Title: ACRS Plant License Renewal
Subcommittee Meeting

Date: Wednesday, April 5, 2006

4 The staff has conducted a detailed and
5 thorough review of the Nine Mile Point Nuclear
6 Station license renewal application which was
7 submitted in May of 2004. Mr. Tommy Le, the Senior
8 Project Manager for this review, will lead our
9 presentation today on the staff's draft safety
10 evaluation report. Mr. Michael Modes, the Region I
11 Inspection Team Leader, will discuss his inspection
12 related activities conducted at Nine Mile Point. In
13 addition, we have several members of the NRR staff
14 that are here to support the meeting and answer any
15 questions that you may have.

NMP1 Emergency (Isolation) Condenser

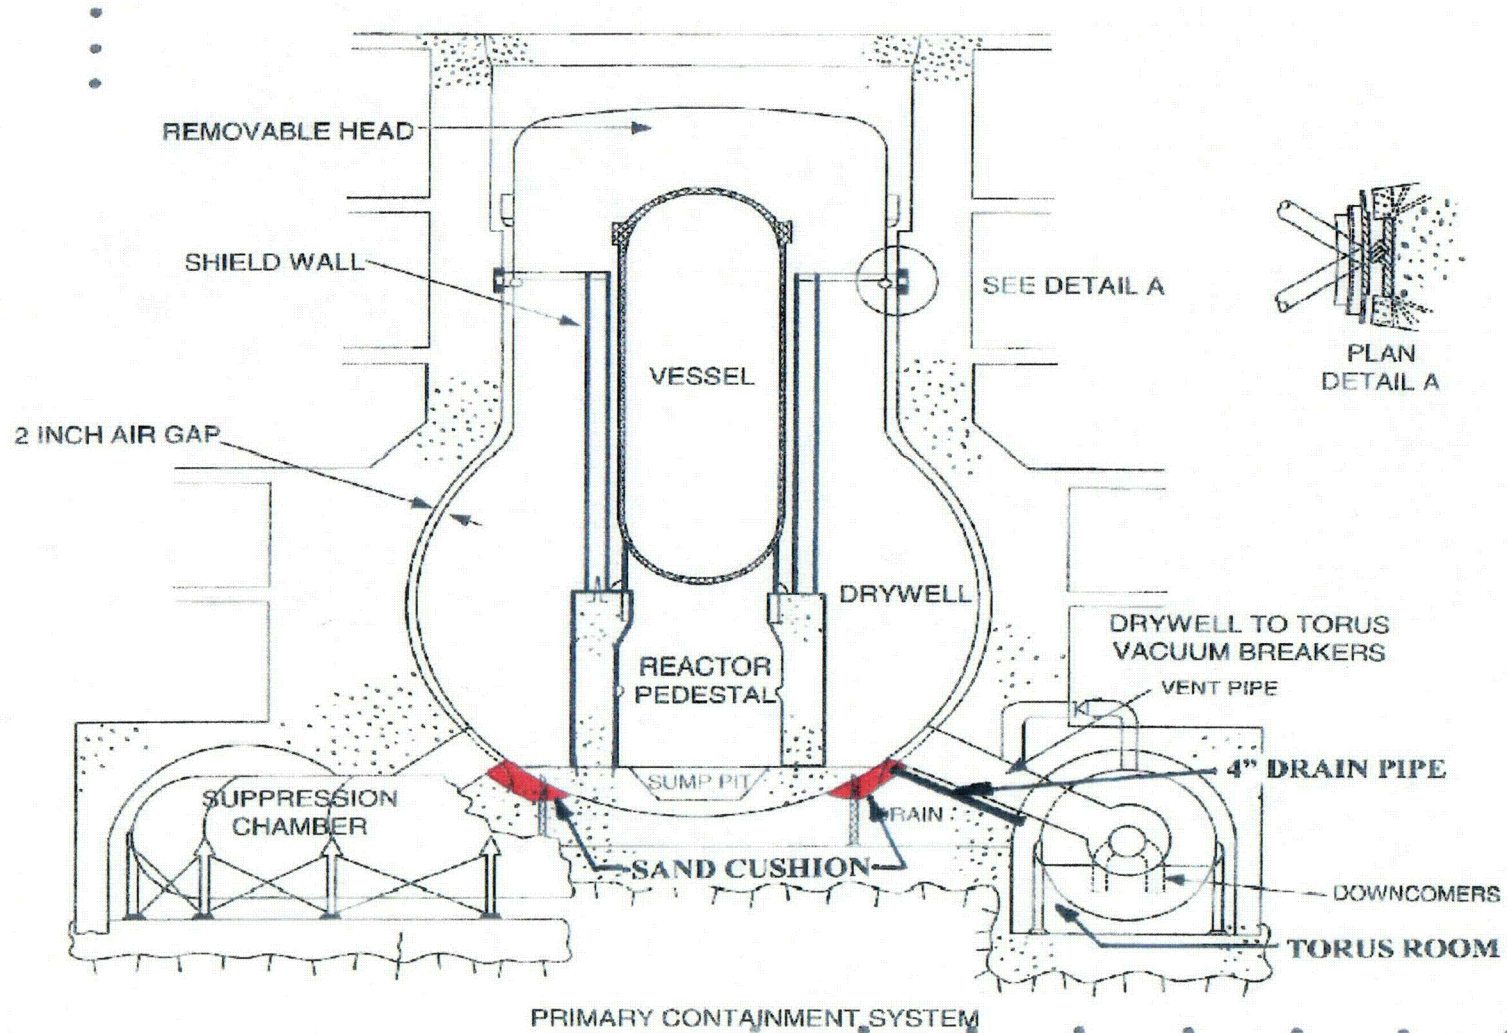
16 MR. MAZZFERRO: Okay. Moving on to
17 Slide 16 and talk a little bit about the isolation
18 condensers. The experience that we had at Nine Mile
19 Point Unit 1 is that in 1997 we had identified
20 leakage through our tubes. So we entered a plant
21 shutdown and actually replaced the tubes. The cause
22 of that cracking was stress cracking of the tubes
23 based on thermal cycling. As it turns out, the
24 water level on the tube side was fluctuating. So we
25 went into a repair. We replaced all the tubes

4 CHAIR SIEBER: I guess I would comment a
5 little bit about this explanation. It's unfortunate
6 the isolation condenser was designed this way and
7 probably should not have been even though I suspect
8 that it met the B-31.1 Code which preceded the ASME
9 Code that most of the plants were built in
10 accordance with. On the other hand, when you do a
11 leakage test, those are usually done at operating
12 conditions and the presumption if you find a leak is
13 that a crack has already occurred and since it's
14 already occurred, there is no margin to crack.

- Identified and repaired tube leaks in 1997
- ECs are of all welded construction - Bases for not performing eddy current testing:
 - Conditions and stressors that were precursors to SCC have been eliminated
 - Lowered temperature of tube and shell side water
 - Maintaining water chemistry on tube and shell side
 - Susceptibility of tubes to SCC reduced by modifications
 - Use of 316L SS tubes and tubesheets
 - Installation of a Keep Fill System to keep tubes flooded & to eliminate thermal cycles
 - Monitoring and detection to ensure adverse conditions will not recur
 - Temperature
 - Water Chemistry
 - Radiation from vents
 - Tube leak test to assure heat transfer intended function is not compromised
 - Periodic performance testing of the HXs

9 DR. CHANG: But given that -- I agree
10 with everything you say, but given the situation,
11 it's already there. What Nine Mile Point has done
12 is the best they can do, use better material, to
13 remove the loading, to remove the stressor and also
14 it's new.
